RAI Volume 2, Chapter 2.1.1.6, Second Set, Number 3:

Explain the development of cut sets used to demonstrate that the double interlock preaction fire-protection system will satisfy the nuclear safety design bases set forth in SAR Table 1.4.3-2. Specifically,

Figure A-1. Fault Tree FIRE-SUPPRESSION

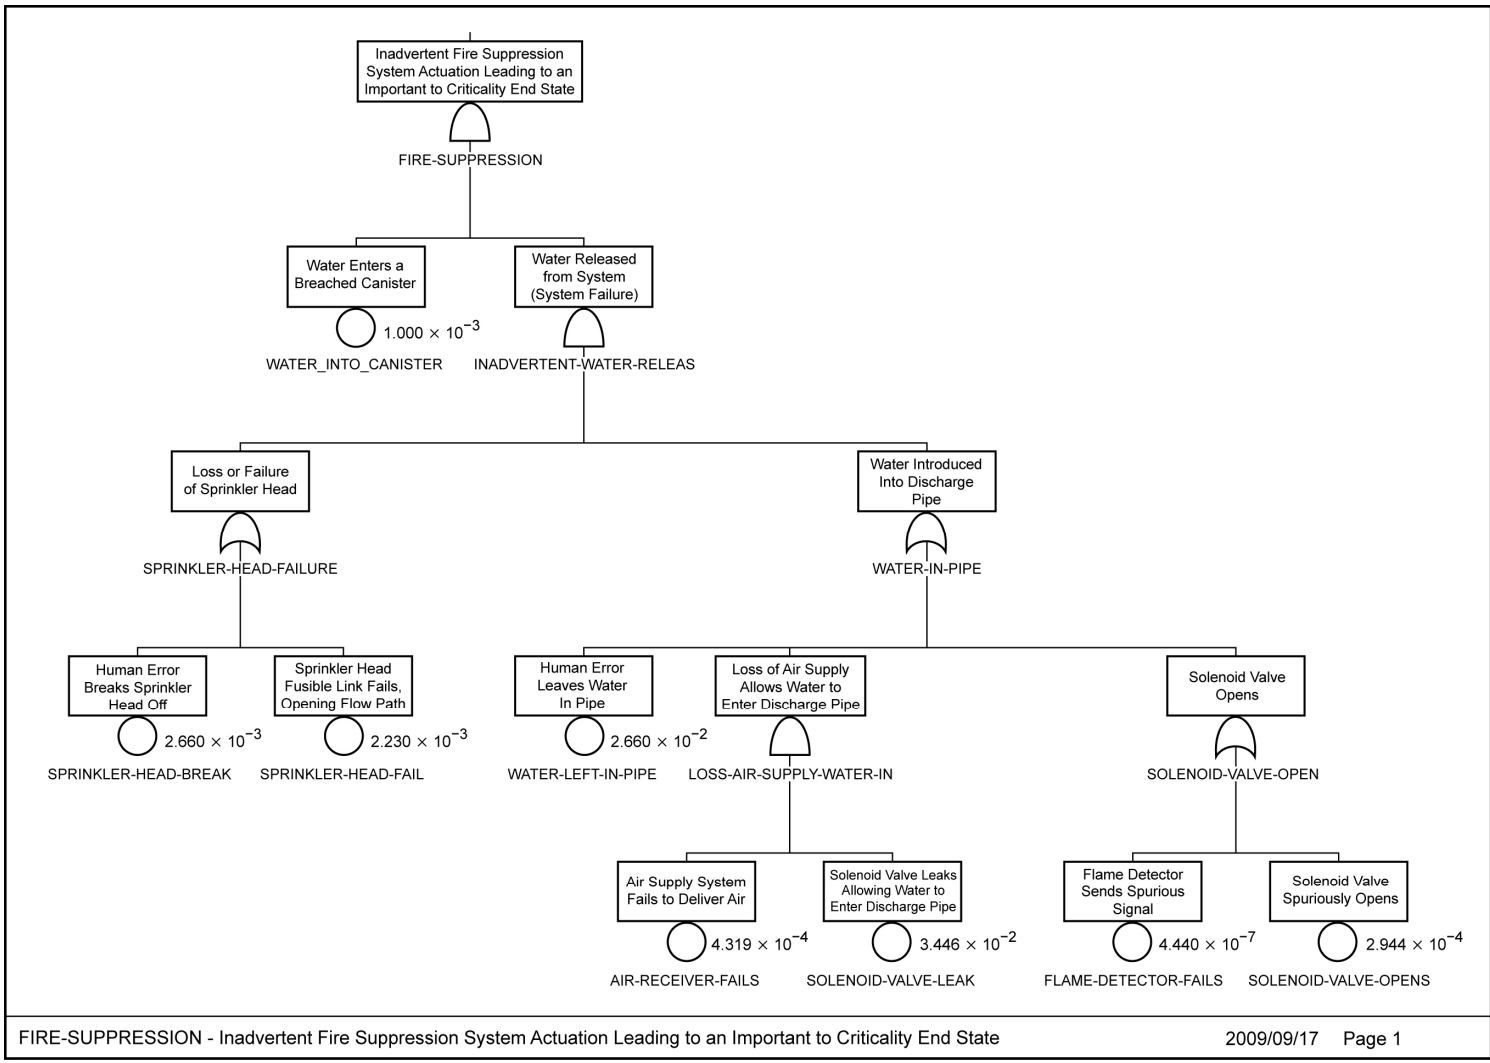
- Explain why alternate event sequences, such as, false fire detection by one of the interlocked fire/smoke detectors was not included as a cut set to determine overall probability of spurious activation of the system and inadvertent introduction of water.
- Justify a human error screening value of 0.025 in conjunction with the sprinkler head failure probability of 1.6×10^{-6} , to determine the overall spurious activation probability.

The derivation of a failure probability for the double interlock preaction system was based on the failure probability of a sprinkler head and simultaneous failure of a solenoid valve as, described in the reliability and event sequence categorization analyses (e.g., BSC 2008a Section 6.2.2.9.1). It appears that there may be additional cut sets, not considered in the failure probability, that may lead to inadvertent introduction of water. For example, malfunction of a fire-detector may trip a solenoid valve, resulting in water discharge from a damaged sprinkler head.

The fault tree developed in this analysis, titled “Fire-Suppression,” is presented in Figure A-1. The top event in this fault tree is “Inadvertent fire suppression system actuation leading to an important to criticality end state.” The fault tree includes events (electro-mechanical control failures and human actions) that can initiate an inadvertent actuation of the fire suppression system in a waste handling area.

The results of this analysis are presented in Table A-5. The mean probability value for the top event of the fault tree was calculated to be 2×10^{-7} . This result applies to both the CRCF and WHF. The top cut set includes the two identified human failure events as well as the probability of water entering a breached canister basic event.

The fault tree analysis results demonstrate that the results calculated with the inclusion of additional component failures and human failure events are bounded by the screening analysis presented in *Canister Receipt and Closure Facility Reliability and Event Sequence Categorization Analysis* (BSC 2009, Section 6.2.2.9.1) in that the screening probabilities exceed the 95th quantile of the results of the more detailed analysis. The nuclear safety design basis controlling parameter probabilities are also bounded by the screening analysis probabilities (reported in SAR Tables 1.9-3 and 1.9-4). The fault tree analysis demonstrates that the addition of components (e.g., the solenoid valve, flame detector, air supply system) did not produce a mean or 95th quantile failure probability for the top event that was greater than the results obtained from the screening analysis. The results from the screening analysis are, therefore, bounding.
